Friends 4 Expo Transit
P.O. Box 64943
Los Angeles, CA 90064
mail@friends4expo.org
www.friends4expo.org

Comments on the Expo Line Phase 2 Draft EIR

March 25, 2009

San Jose aerial light rail structure example for Sepulveda and Olympic

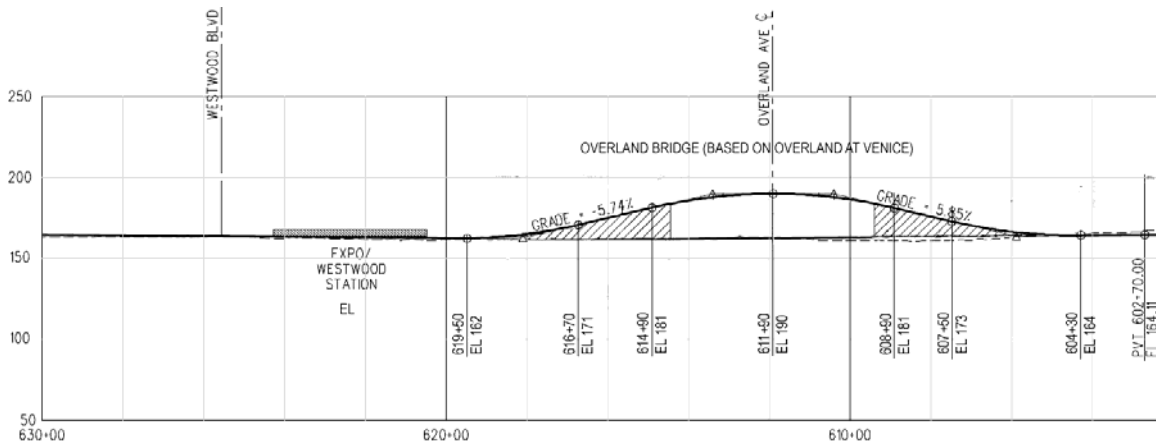
The photo on page 3 of aerial light rail along Capitol Avenue in San Jose gives an indication of the impact of elevating Expo along Sepulveda or Olympic. Not to mention property takes and loss of many mature street trees.

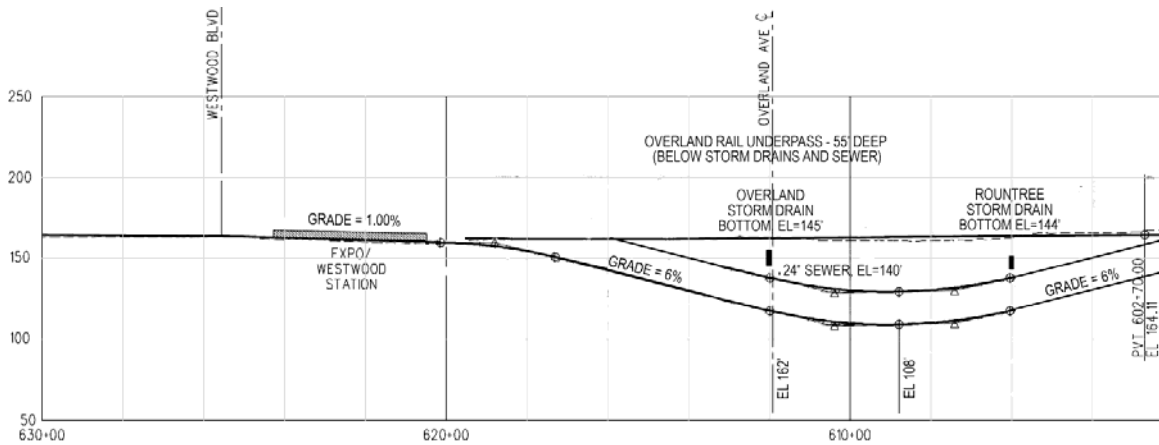
7. If further Grade Crossing analysis in response to LADOT calls for Overland to be grade separated:

A. We'd recommend a **rail bridge** be as low as possible to reduce visual impact (including removing the existing hump on Overland at the old railroad crossing), combined with landscaping and natural slopes in lower parts of its ramps. The image below shows its ramp from Richland and Selby.

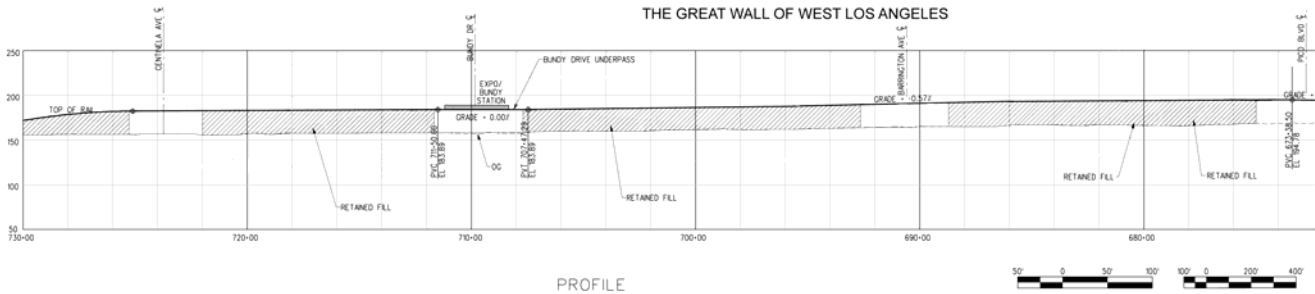
9. We support the **at-grade crossing at Westwood**, noting that LADOT's only objection was loss of street parking, and the width of only *one to four lots* hardly constitutes the “severe inconvenience” of “extensive walking distances”.
10. Here is a photo of southbound traffic on **Centinel** stopping across Expo during a typical PM commute. Will queue-cutter signal plans work here (page 3.2-25)?
